# TULSA METROPOLITAN AREA PLANNING COMMISSION

For Meeting No. 2500

December 19, 2007 1:30 PM

Detail Site Plan – North side E. 83<sup>rd</sup> Place South between South 111<sup>th</sup> E. Ave and South 112<sup>th</sup> E. Ave.; Reserve Areas A and C. Ridgecrest subdivision; CO.

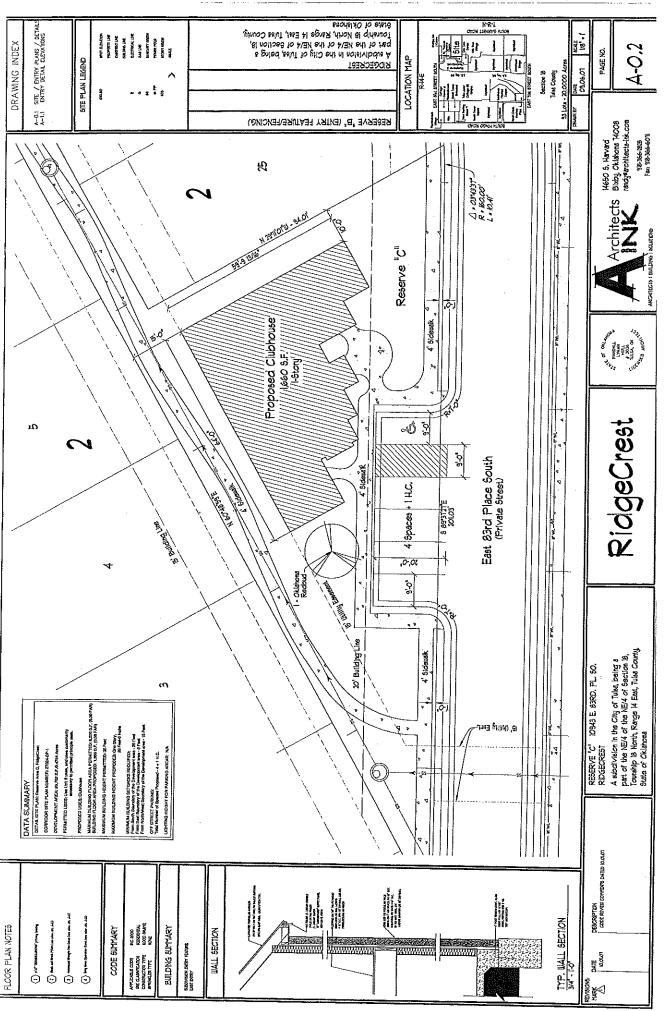
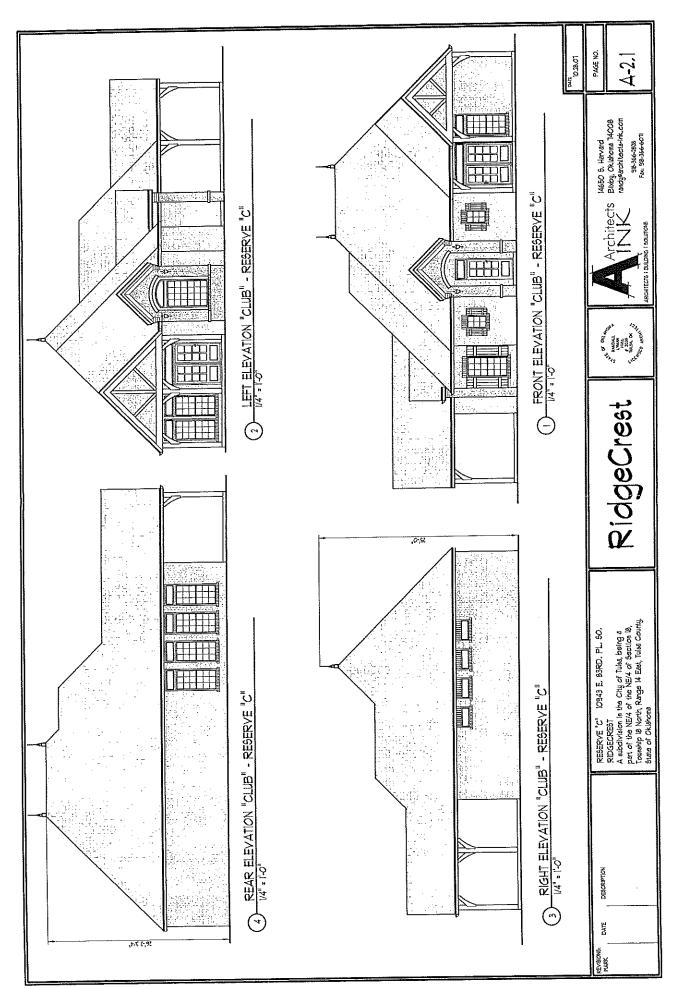
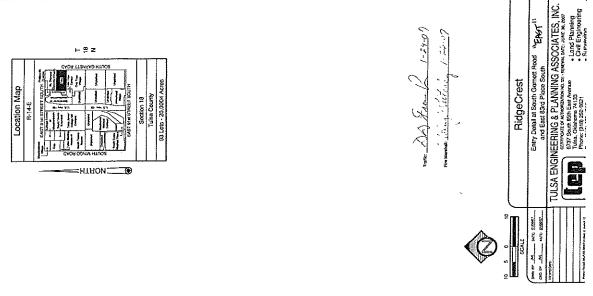
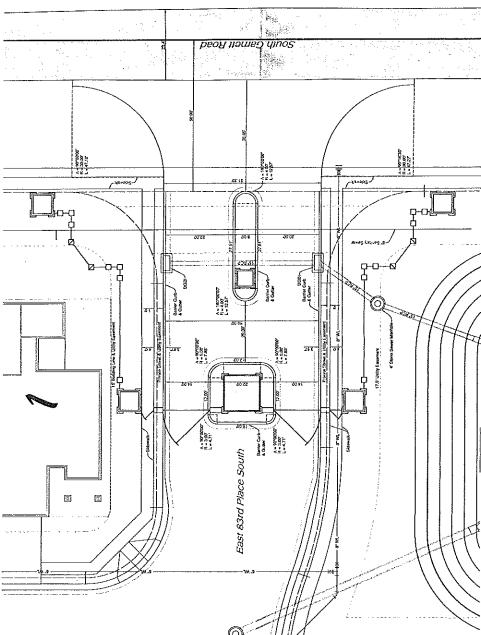
The applicant is requesting approval of a detail site plan for two gated entries and a pool house located in Reserve Areas A and C respectively, Ridgecrest Subdivision (plat 6129). The proposed use of the reserve areas are in conformance with the permitted Reserve Area Development Standards of Z-7024-SP-1.

The proposed site plan for the pool house located in Reserve Area C meets building floor area, height, setback and parking requirements. Vehicular access to the site is provided from one access point from East 83<sup>rd</sup> Place South. Pedestrian access is provided on the northeastern portion of the site allowing pedestrian access from the lots to the east and north, as well as internal pedestrian circulation.

Entry gates and guardhouses located in Reserve Area A (both east and west entries) meet the minimum required setback distances and development standards, and have been approved by the City of Tulsa Fire Marshall and City of Tulsa Traffic Engineer as meeting all applicable codes and requirements.

PUD development standards state that sidewalks and a bus-stop pad be included in the development of entry gates in Reserve Area A along Garnett Road within 50 feet of the southern boarder of the PUD boundary. Tom Raines of the City of Tulsa Engineering Department has recommended to the applicant that this portion of the project be included in the proposed widening of Garnett Road within the vicinity of Reserve Area A. Staff agrees with this recommendation.

Therefore, staff recommends **APPROVAL** of detail site plans for Reserve Areas A and C, Ridge Crest Subdivision, Z-7024-SP-1.

**Detail Site and Landscape Plan** – The Dance Pointe, 9353 E. 95<sup>th</sup> Ct. South; Tract 1A, Part of Lot 3, Block 1; 9600 Mingo Office Park; OL/PUD

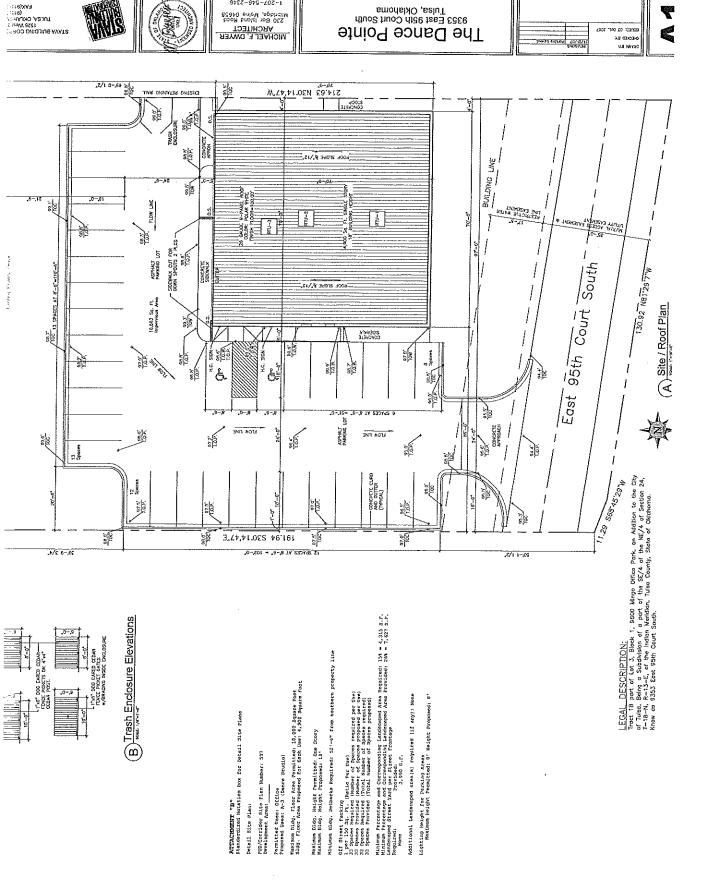
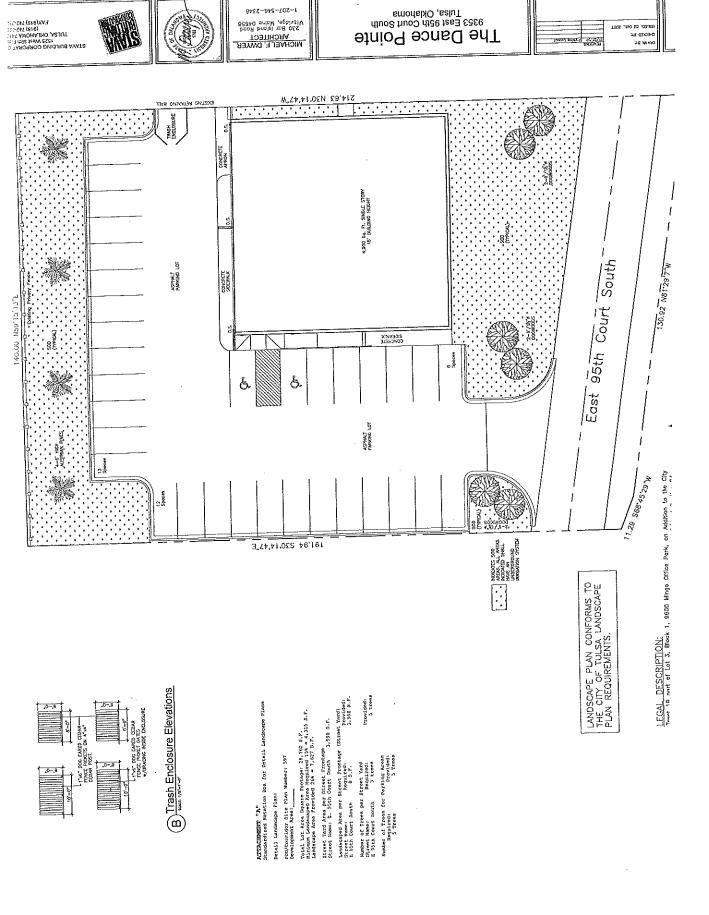
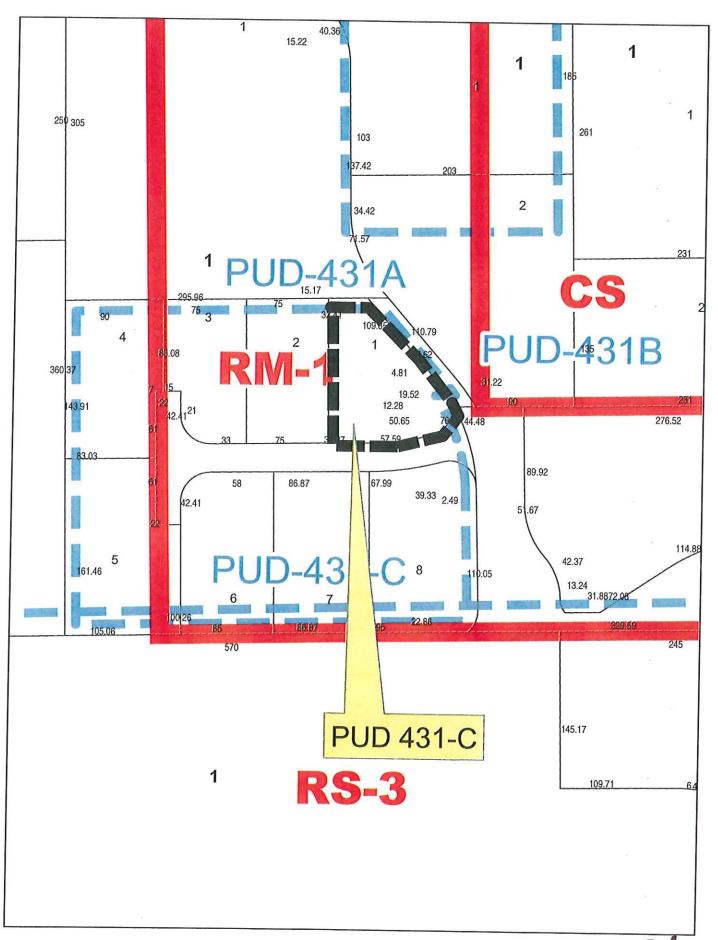
The proposed site plan meets building floor area, height, setback and parking requirements. Access to and within the site is provided from one access point from East 95<sup>th</sup> Court South as required and one internal access point on the north-east corner of the site providing access from the adjacent lot to the east.

The site meets landscape requirements per development standards and the zoning code, and a landscaped buffer is provided along the north and south boundary of the lot. A six-foot screening fence is provided along the north boundary in conformance with development standards. There are no plans for free-standing light poles in the parking lot, and any lighting attached to the building will be directed down and away from the residential area to the north per the Kennebunkport formula.

PUD development standards state that the internal access drive be setback no less than 50' from the residential development to the north. However, development standards allow deviations from this during detail site plan review. The applicant is proposing the internal access drive to be placed 43' 9 ¾" from the residential development area to the north. Because the applicant is seeking a reduction of 6' 2 ¼", there is a six-foot privacy fence located on the lot line in common with the R District and the access drive runs parallel to the R District, staff views this request as minor in nature having no significant impact on the residential development.

Therefore, staff recommends APPROVAL of detail site and landscape plans for Tract 1A, Part of Lot 3, Block 1; 9600 Mingo Office Park, PUD-597-3.

Detail Site Plan – Copper Oaks Office Park; 6321 E. 102<sup>nd</sup> St. S.; Lot 1, Block 1 – Copper Oaks Office Park; CS

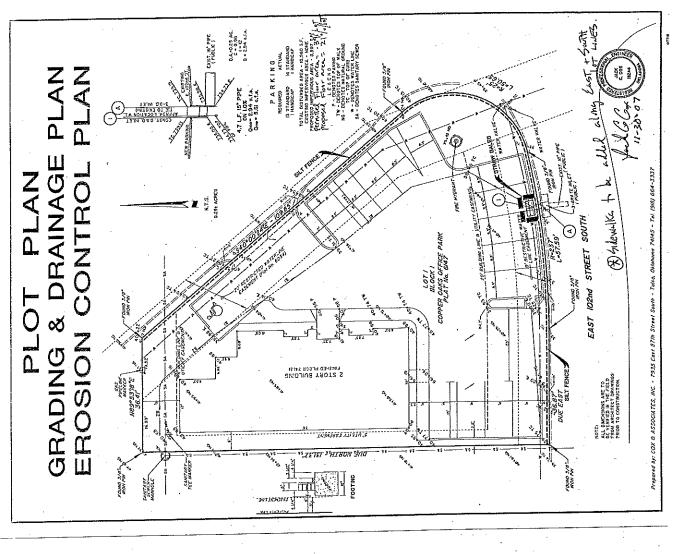
The detail site plan is missing required sidewalks along the mutual access easement along the eastern boundary of the lot, and along South 102<sup>nd</sup> Streets as required by PUD development standards. However, staff did verify with the applicant that sidewalks will be added to the site plan, prior to approval by the TMAPC staff.

Therefore, staff recommends **APPROVAL** of detail plan for PUD-431-C - Copper Oaks Office Park subject to the following minor revisions to the detail site plan submitted: add sidewalks along east boundary of the PUD/mutual access easement with Lot 2. Block 1 – South Tulsa Baptist Church Extended (plat no. 6034) and along 102<sup>nd</sup> Street South
